Date: April 24, 2026

Project Name: UHN – Lab Histology Ventilation Upgrade
Project Number: 115625050

This Addendum shall form part of the Contract Documents and is to be read, interpreted and coordinated with all other parts. The cost of all work contained herein shall be included in the Contract sum. The following revisions supersede the information contained in the original specifications and drawings issued for the above-named project. Acknowledge receipt of this Addendum by inserting its number in the STIPULATED PRICE BID FORM.

Title
ROOF - HVAC RENOVATION PLAN

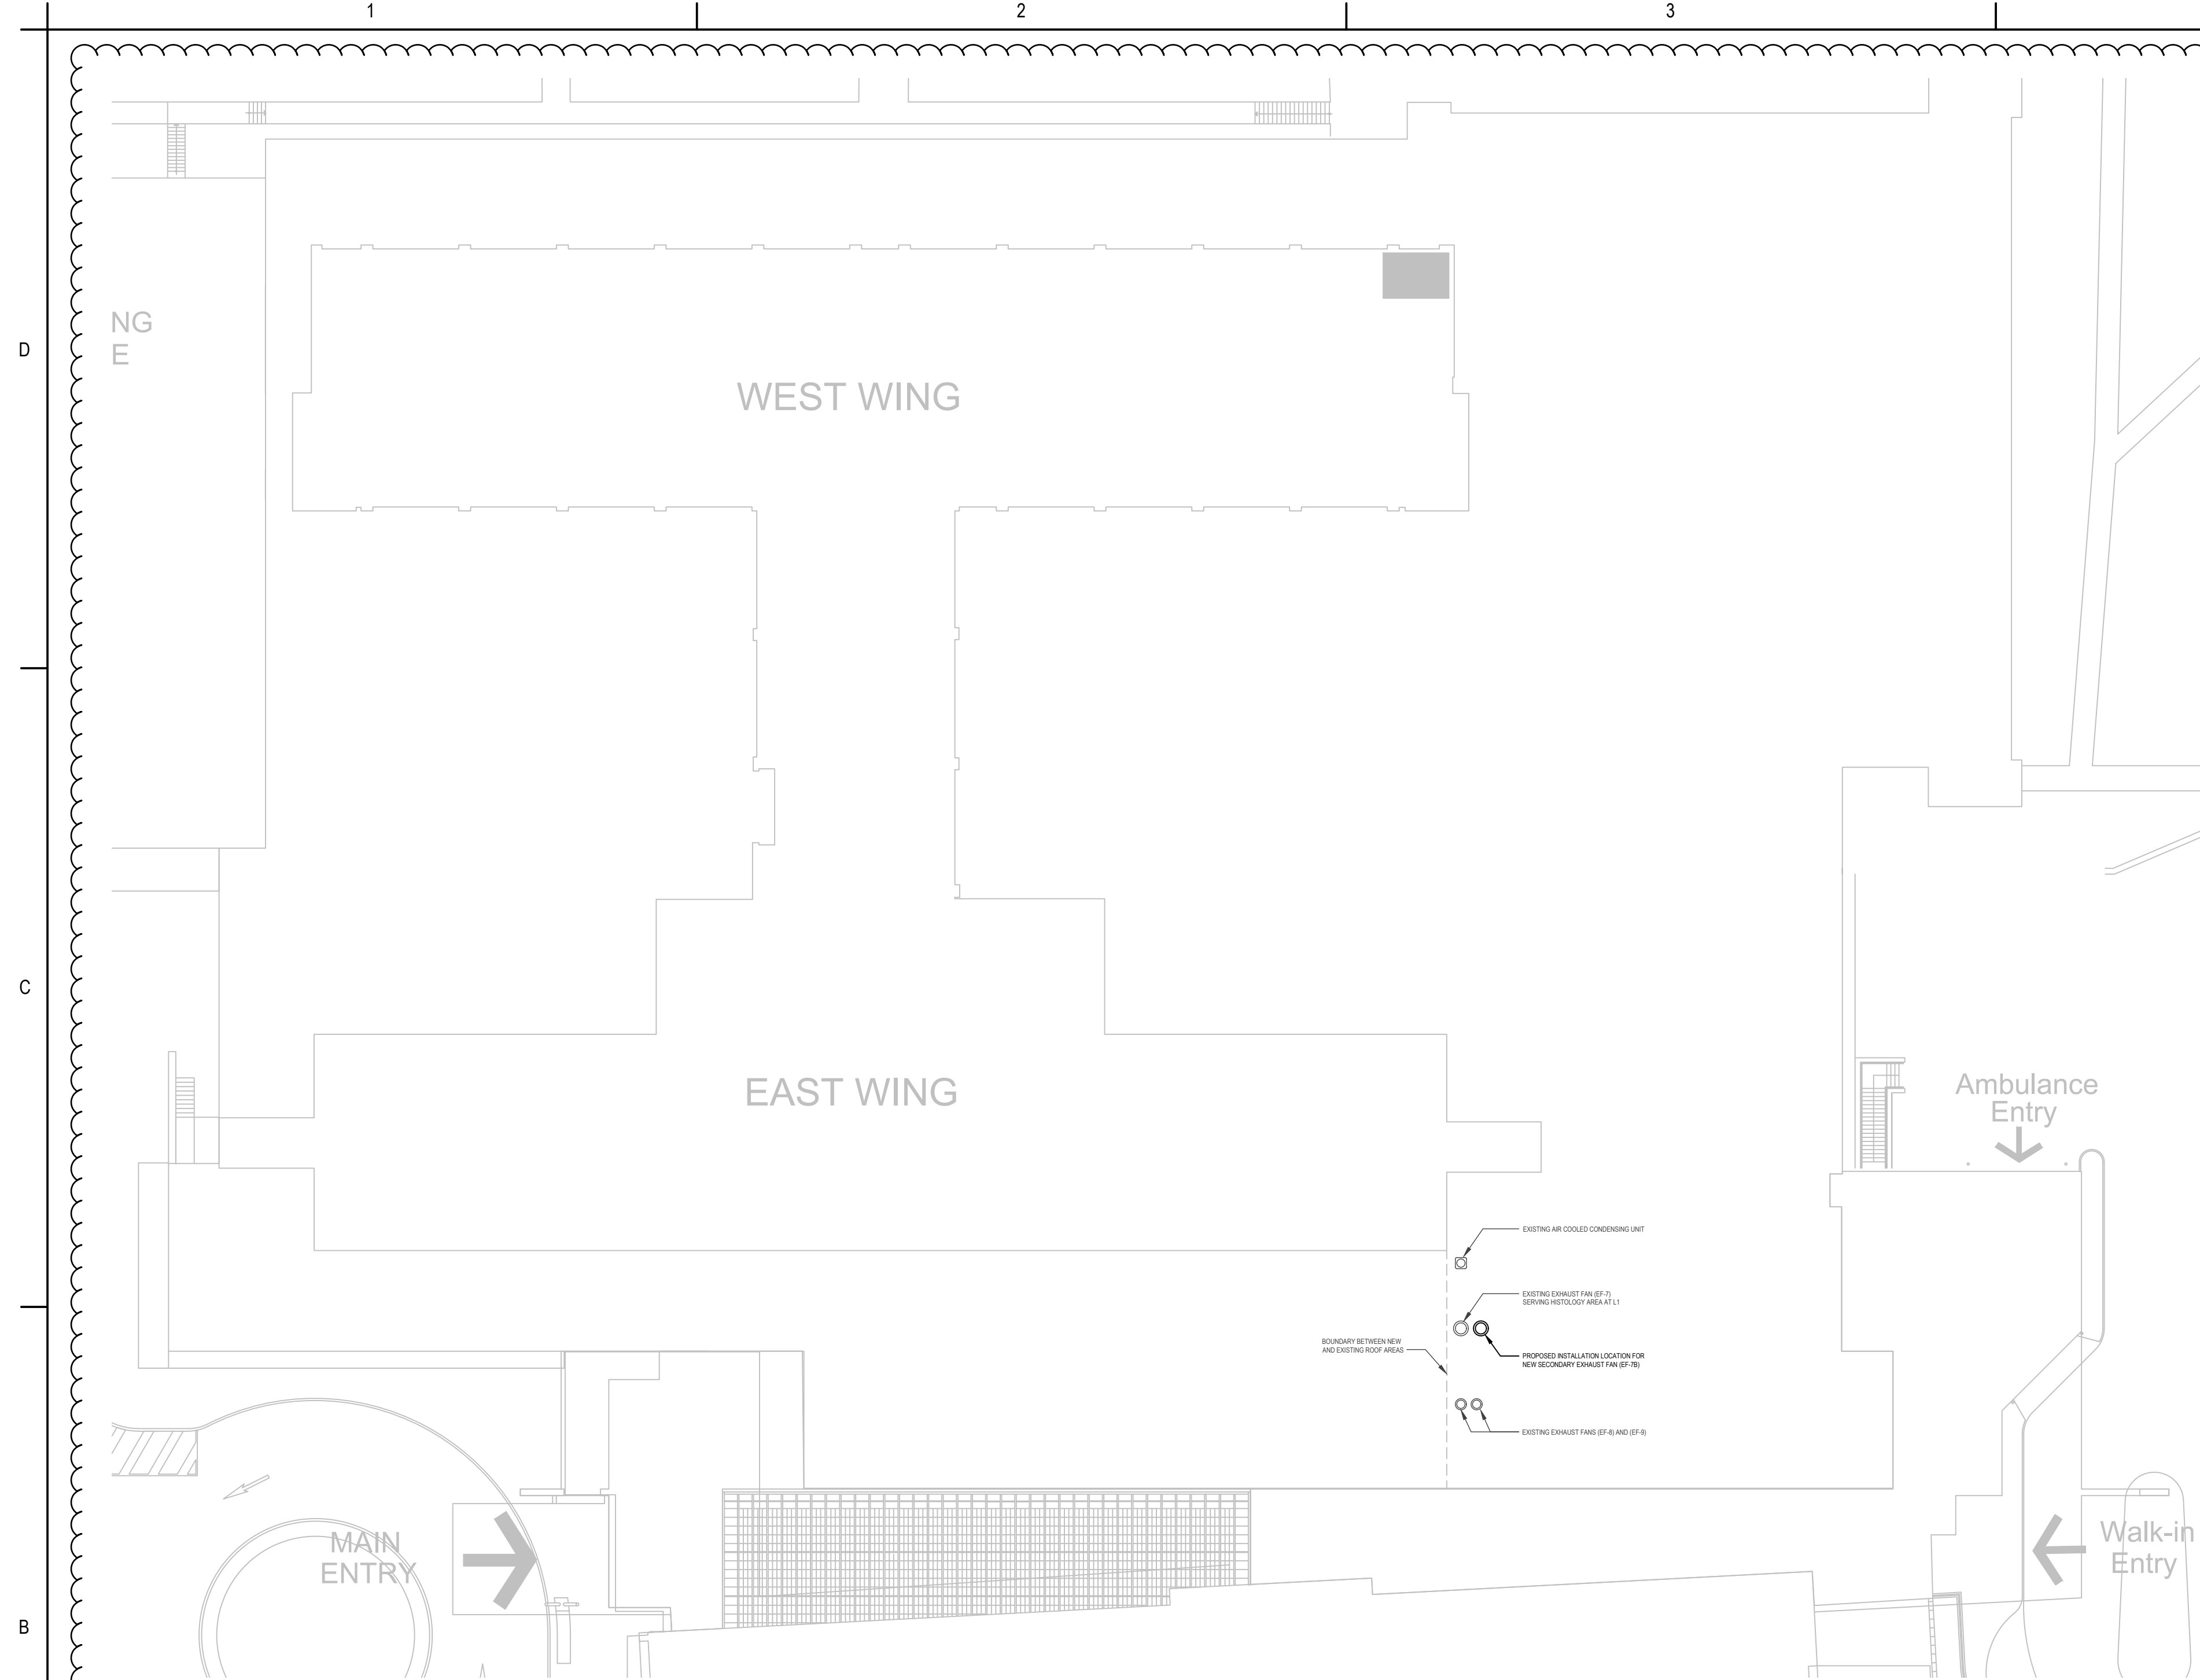
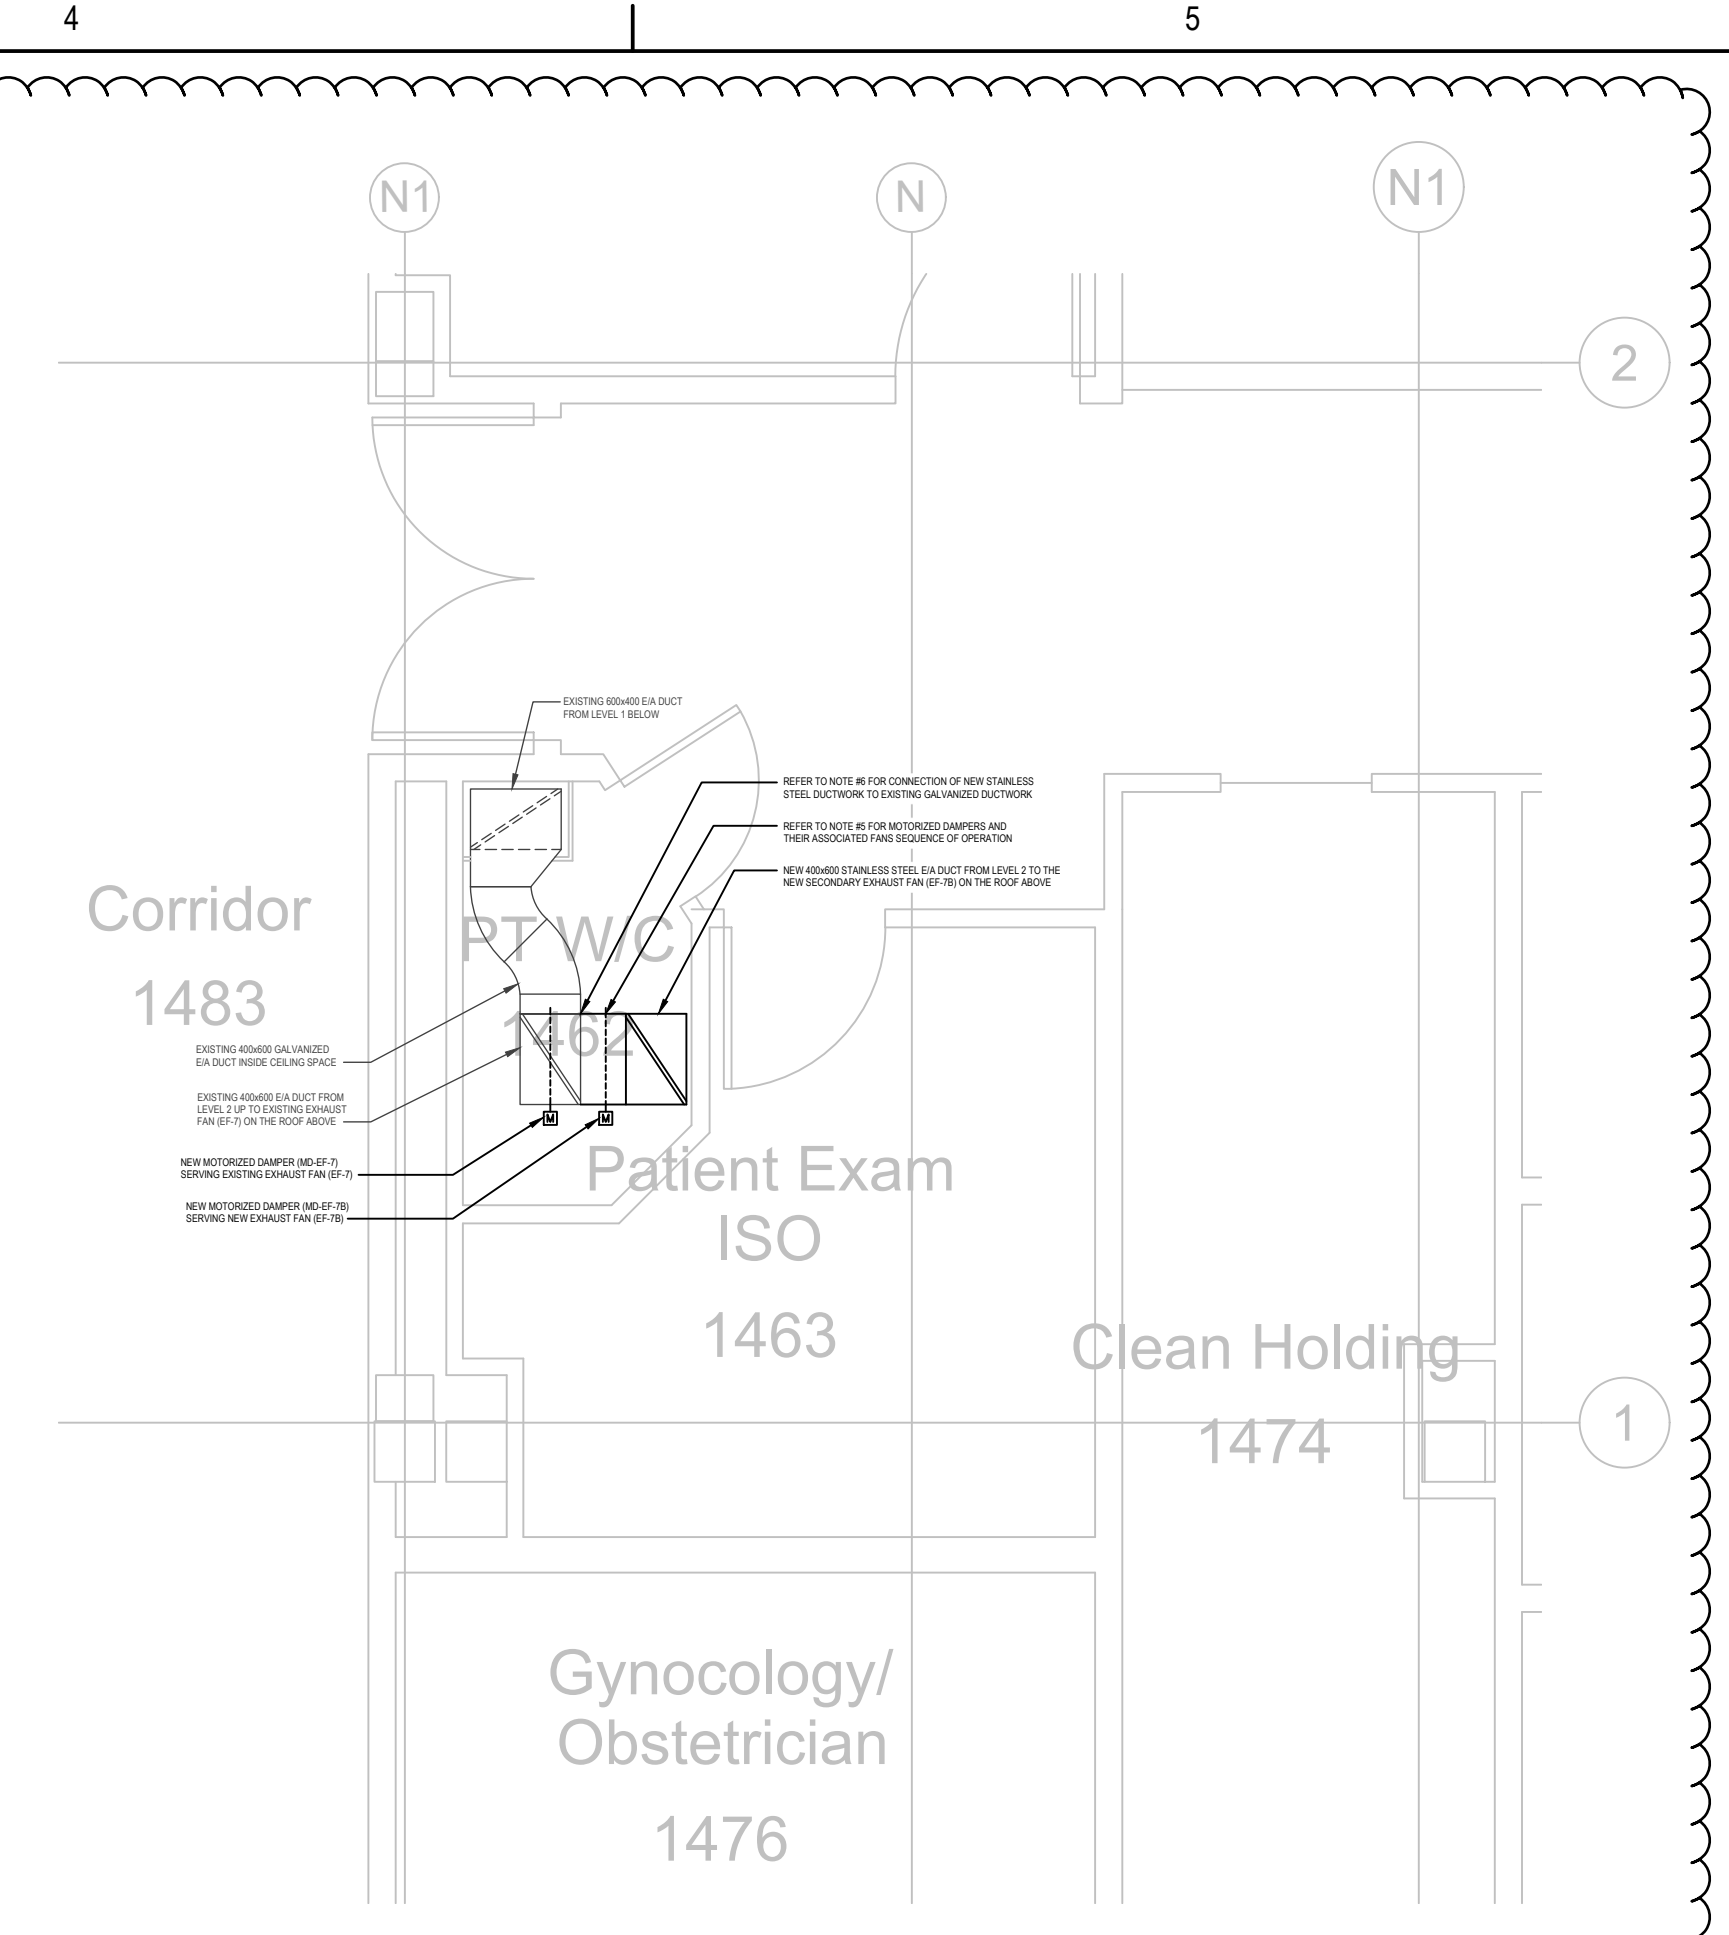
Please refer to attached new mechanical drawing M-104 (Roof – HVAC Renovation Plan) for addition of secondary (standby) exhaust fan serving the Histology exhaust.

New exhaust fan (EF-7B) to be installed adjacent to the existing exhaust fan (EF-7). Refer to the “Exhaust Fan Schedule” in M-104 for new equipment specifications. Refer to “General Notes” in M-104 for construction notes and sequence of operations.
